9 June 2021

**Ryan Corner Wind Farm proposed wind turbine modification and micro-siting amendment**

Figure 1- Ryan Corner Wind Farm endorsed and proposed wind turbine overlay

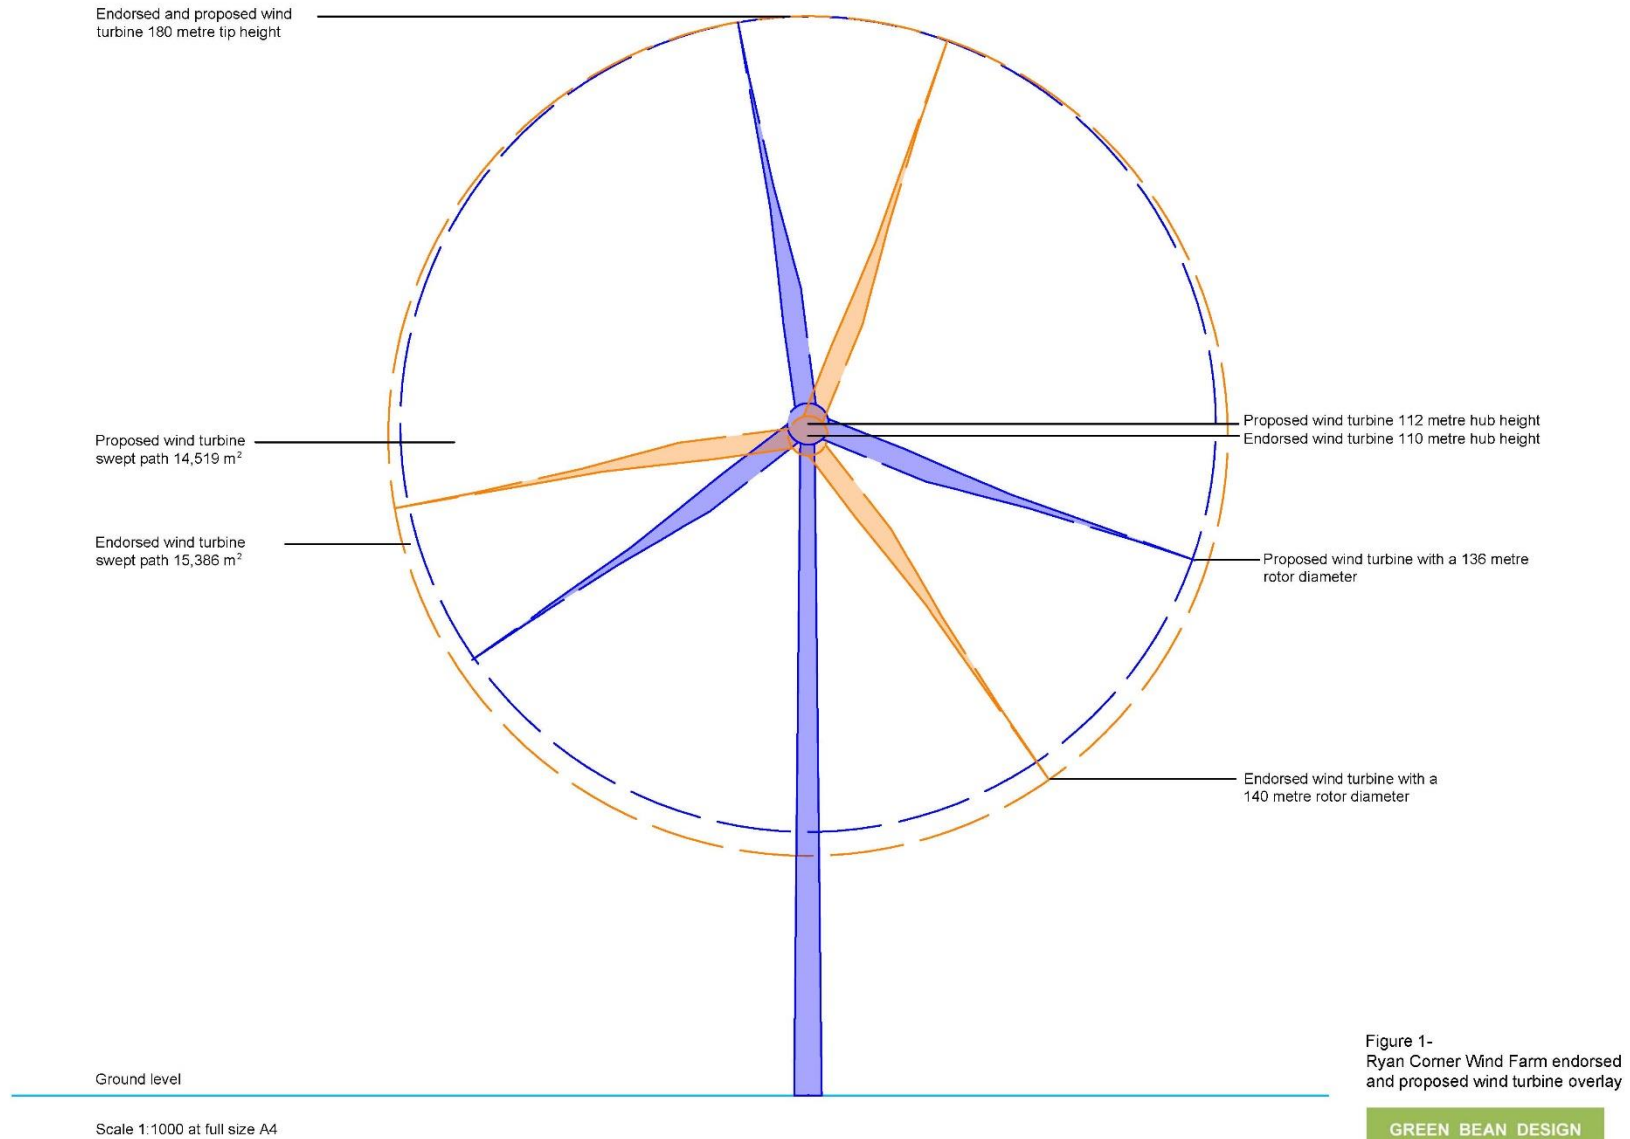
The endorsed wind turbine tip height at 180 metres would remain unchanged. An overlay of the endorsed and proposed wind turbine is illustrated in **Figure 1**.

In consideration of the above, and as illustrated in **Figure 1**, it is highly unlikely that the proposed wind turbine will result in any increased degree of visibility or additional visual impacts to surrounding key significant view locations.

Figure 2 – Viewshed from non-stakeholder dwelling RY113 (377 Fingerboard Road)

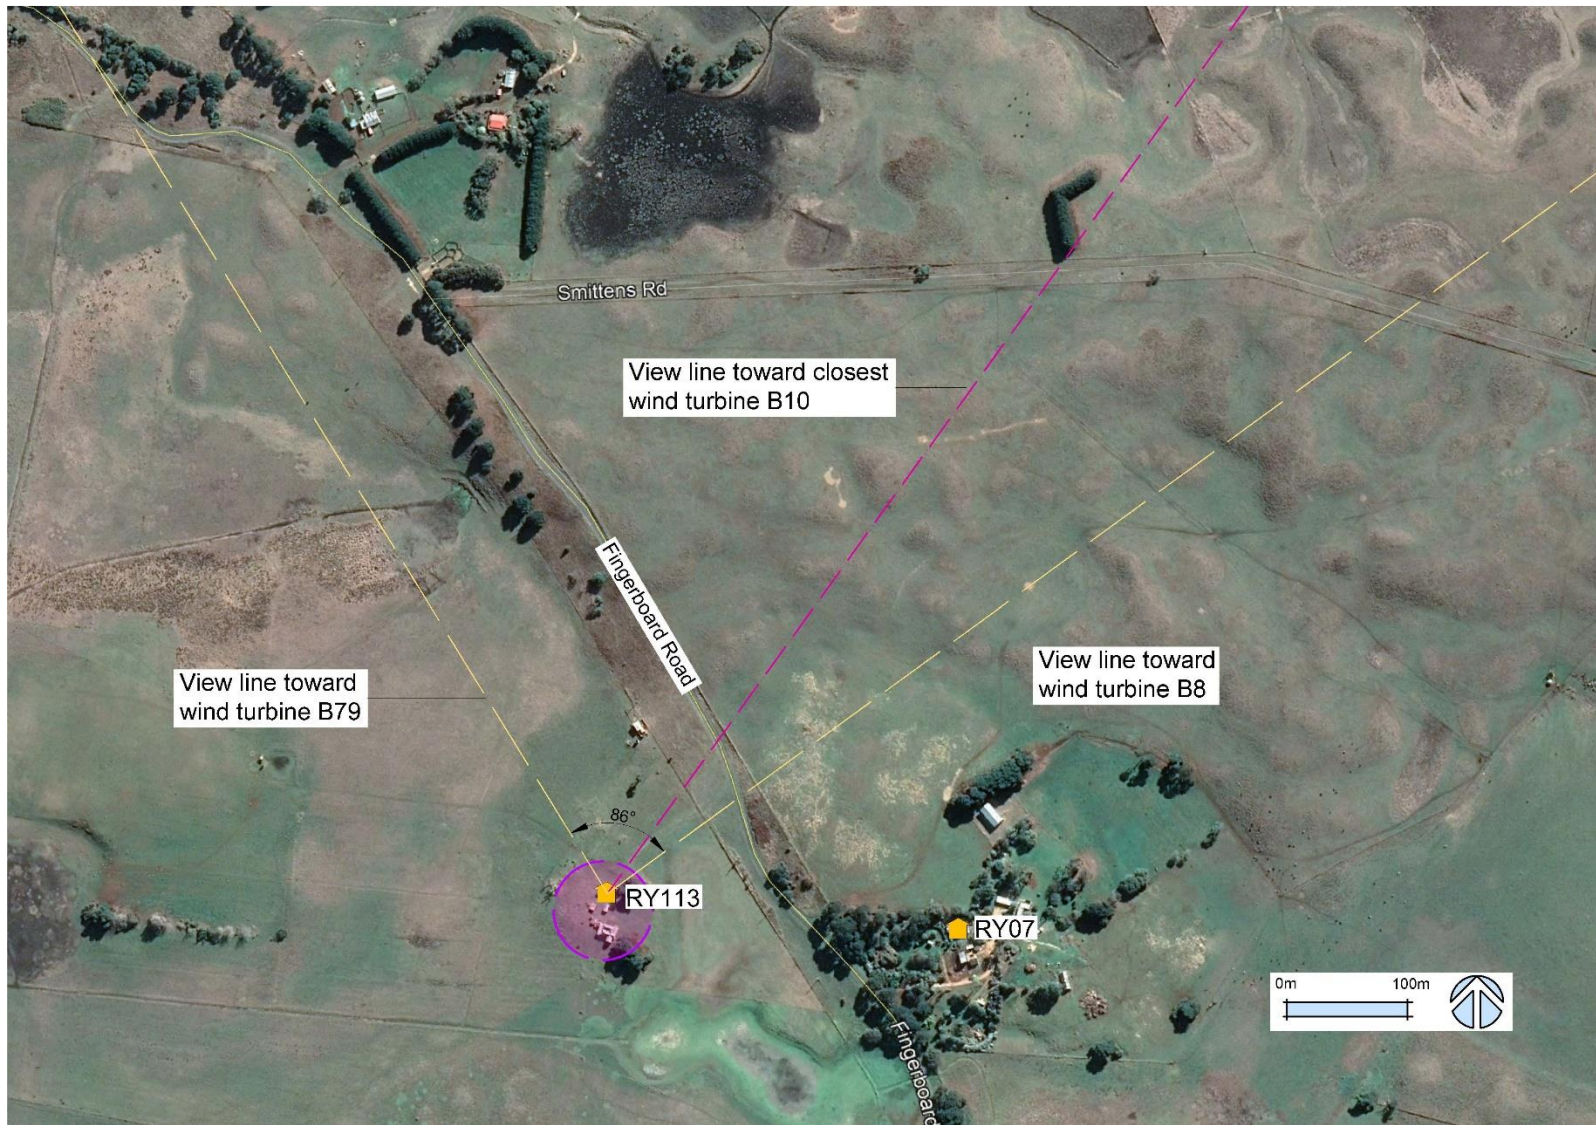
Dwelling RY113 is located around 138m south west of Fingerboard Road and 295m west of non-stakeholder dwelling RY07. The general field of view from the dwelling toward the wind turbines extends to around 86 degrees and is defined by views between wind turbine B79 around 2.5km to the north west and wind turbine B8 around 3.1km to the north east of the dwelling. The closest wind turbine (B10) is located north north east of the dwelling at around 1.14km. There is no significant tree cover or screening immediately beyond the dwelling with views likely extending toward most wind turbines within the project site. The onsite substation is unlikely to be visible from the dwelling. Given the proximity of wind turbines to the dwelling, the number of wind turbines likely to be visible and a general lack of existing screening, the wind farm is considered to have a potential high visual effect on dwelling RY113. We understand that dwelling RY113 would be eligible for off-site landscape visual mitigation works in accordance with Condition 5 (a) of the Planning Permit. Screen

planting to the north west through to north east of the dwelling may provide some degree of visual mitigation in the mid to long term.

Figure 4 – Viewshed from non-stakeholder dwelling RY115 (53 St Helens Road Yambuk)

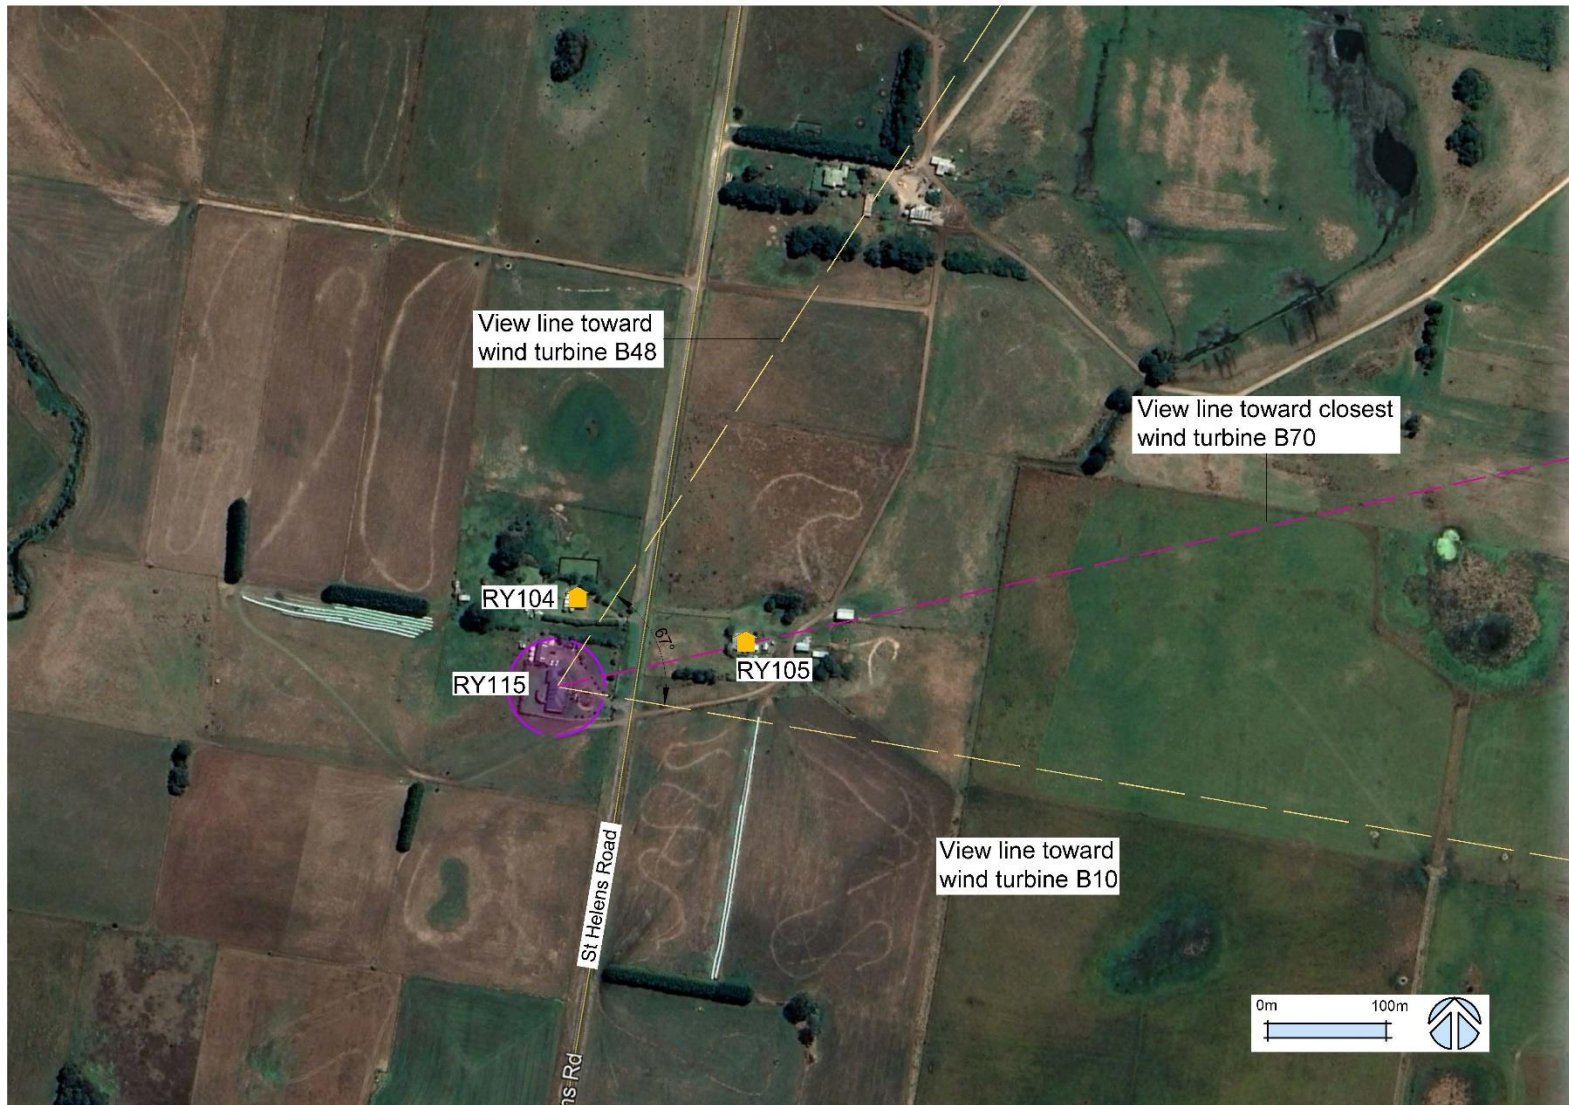
Dwelling RY115 is located directly off St Helens Road and immediately south of non-stakeholder dwelling RY104. The general field of view from the dwelling toward the wind turbines extends to around 67 degrees and is defined by wind turbines B48 around 5km to the north north east and wind turbine B10 around 4km to the east south east of the dwelling. The closest wind turbine (B70) is located north east of the dwelling at around 2km. There is some tree screen planting to the north of the dwelling and additional tree planting to the east of St Helens Road associated with dwelling RY105. Views from the dwelling and curtilage are likely to extend toward some wind turbines within the project site. The onsite substation is unlikely to be visible from the dwelling. Given the proximity of wind turbines to the dwelling, the number of wind turbines likely to be visible and a general lack of significant screening, the wind farm is considered to have a potential moderate visual effect on dwelling RY115. We understand that dwelling RY115 would be eligible for off-site landscape visual mitigation works in accordance with Condition 5 (a) of the Planning Permit. Screen planting to the north east through to south south east of the dwelling curtilage may provide some degree of visual mitigation in the mid to long term.
